ENGINEERING CHANGE PROPOSAL (ECP), PAGE 1				1. DATE (YYMMDD) 950221		Form Approved OMB No. 0704-0188	
Public reporting burden for this collection of information is estimated to average 2 hours per response, including the time for reviewing instructions, searching existing data sources, gathering and maintaining the data needed, and completing and reviewing the collection of information. Send comments regarding this burden estimate or any other aspect of this collection of information, including suggestions for reducing this burden to Department of Defense, Washington Headquarters Services, Directorate of Information Operations and Reports, 1215 Jefferson Davis Highway, Suite 1204, Arlington, VA 22202-4302, and to the Office of Management and Budget, Paperwork Reduction Project (0704-0188), Washington, DC 20503. PLEASE DO NOT RETURN YOUR COMPLETED FORM TO EITHER OF THESE ADDRESSES. RETURN COMPLETED FORM TO THE GOVERNMENT ISSUING CONTRACTING OFFICER FOR THE CONTRACT / PROCURING ACTIVITY NUMBER LISTED IN ITEM 2 OF THIS FORM.						2. PROCURING ACTIVITY NO. G5S3008

8. ECP DESIGNATION				9. BASELINE AFFECTED			
a. MODEL / TYPE M9		b. CAGE CODE 19200		c. SYSTEM DESIGNATION PISTOL, SEMIA

Figure 9a. Engineering Change Proposal - Page 1

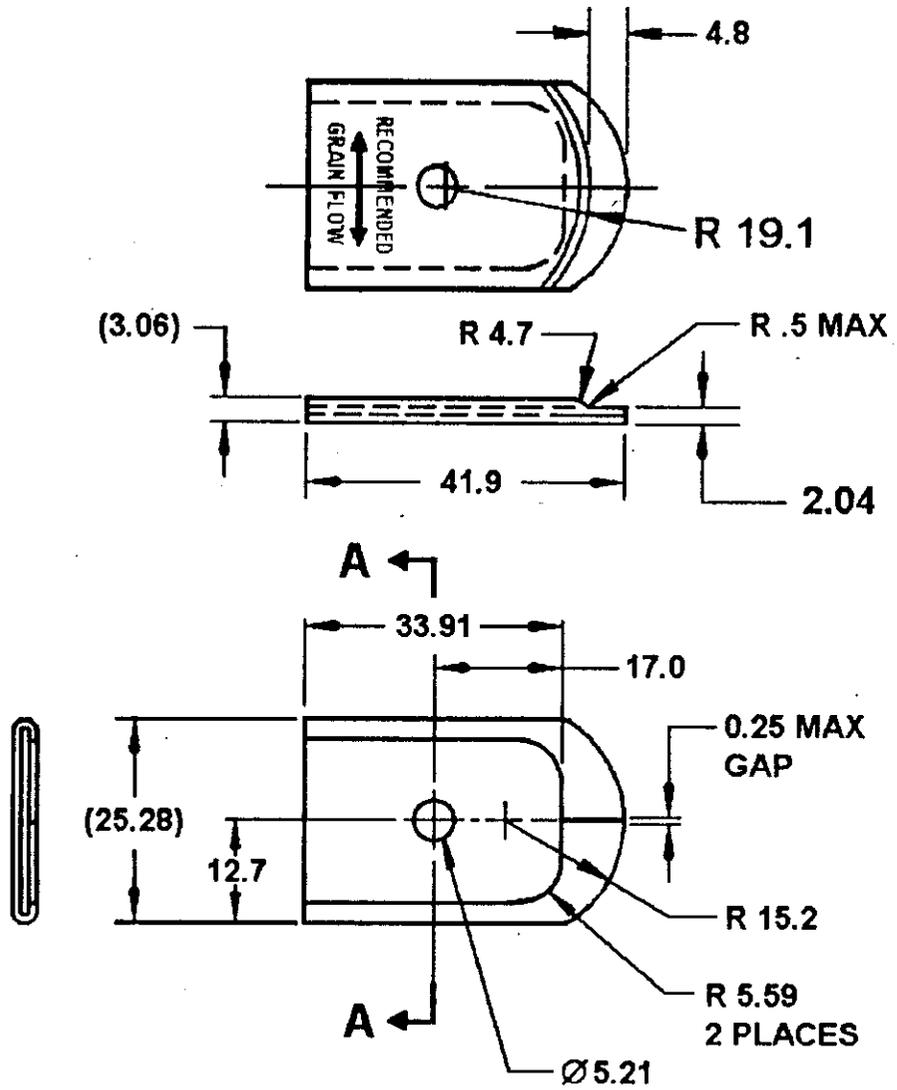
16. CONFIGURATION ITEM NOMENCLATURE STAINLESS STEEL PLATE			18. ALL LOWER LEVEL ITEMS AFFECTED a. NOMENCLATURE NONE b. PART NO NONE c. NSN NONE			19. DESCRIPTION OF CHANGE DELETE: FLOOR PLATE MAGAZINE - ALUMINUM ALLOY CASTING SUBSTITUTE: FLOOR PLATE MAGAZINE - STAINLESS STEEL

20. NEED FOR CHANGE FLOOR PLATE MAGAZINE FABRICATED FROM ALUMINUM CASTING HAS A TENDENCY TO CRACK WHEN DROPPED FROM 3 TO 4 FT. HIGH. STEEL PLATE PRECLUDES THIS EVENT.			21. PRODUCTION EFFECTIVITY BY SERIAL NUMBER NONE			22. EFFECT ON PRODUCTION DELIVERY SCHEDULE NONE-IF ADOPTED WITHIN 30 DAYS

13. DESCRIPTION OF REVISION REDRAW IN ACCORDANCE WITH ATTACHED SKETCH.			
14. THIS SECTION FOR GOVERNMENT USE ONLY			
a. (X one)	<input checked="" type="checkbox"/>	(1.) Existing document supplemented by this NOR may be used in manufacture.	
	<input type="checkbox"/>	(2.) Revised document must be received before manufacture may incorporate this change.	
	<input type="checkbox"/>	(3.) Custodian of master document shall make above revision and furnish revised document.

9. TITLE OF DOCUMENT	10. REVISION LETTER	19200	D9346414
FLOORPLATE, MAGAZINE	a. CURRENT	b. NEW	11. ECP NO.
	A		L7S2074
12. CONFIGURATION ITEM (OR SYSTEM) TO WHICH ECP APPLIES			Sheet 1 of 1
PISTOL, 9mm, M9

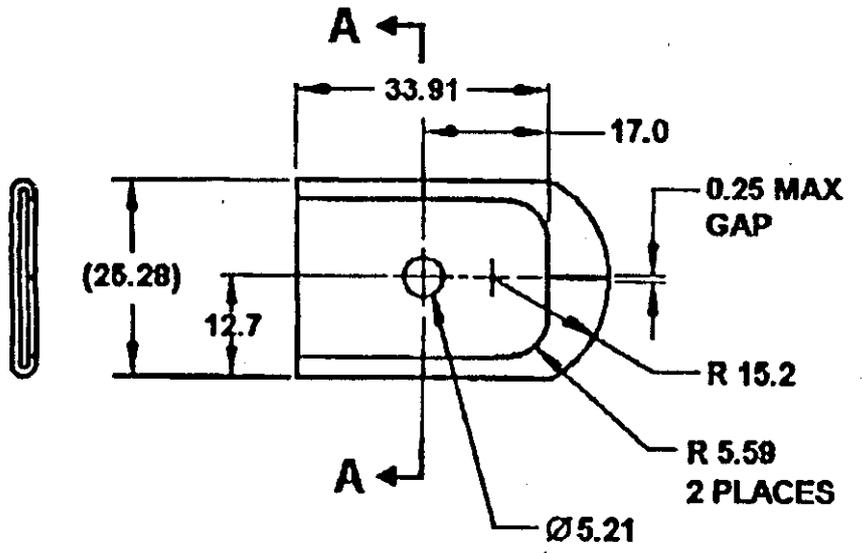
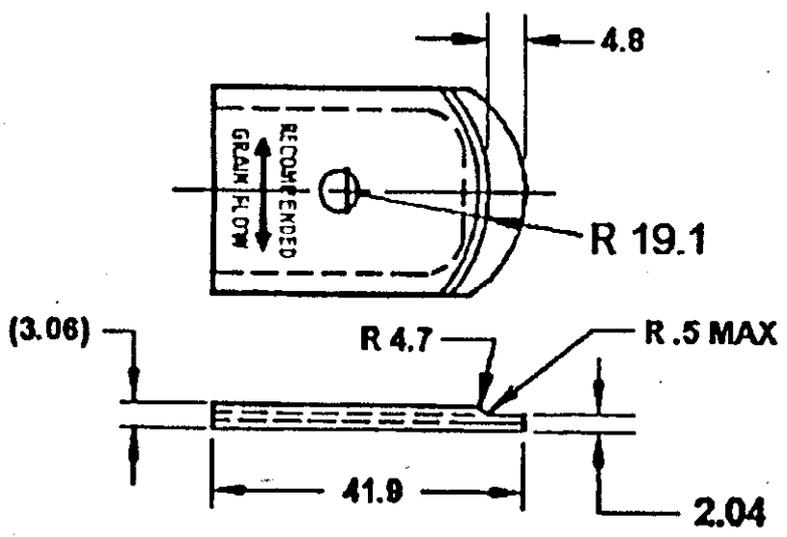
13. DESCRIPTION OF REVISION			
ADD: To the drawing Check-Mate proprietary statement was inadvertently omitted on ERR-G6S3134.			
<div style="border: 2px solid black; padding: 10px; width: fit-content; margin: auto;"> <p>PATENT PENDING TO CHECK-MATE INDUSTRIES, INC., 777 MOUNT AVE, WYANDANCH, N.Y., OFFERING UNLIMITED DATA, DESIGN, DRAWING AND PATENT RIGHTS TO THE UNITED STATES DEPARTMENT OF DEFENSE (OR COMPONENTS THEREOF) ONLY.</p> <p>NOTICE: THIS DRAWING IS FOR USE ONLY IN CONNECTION WITH PROCUREMENT BY THE UNITED STATES DEPARTMENT OF DEFENSE AND SHALL NOT BE USED NOR REPRODUCED EITHER WHOLLY OR IN PART FOR ANY OTHER PURPOSE.</p> </div>
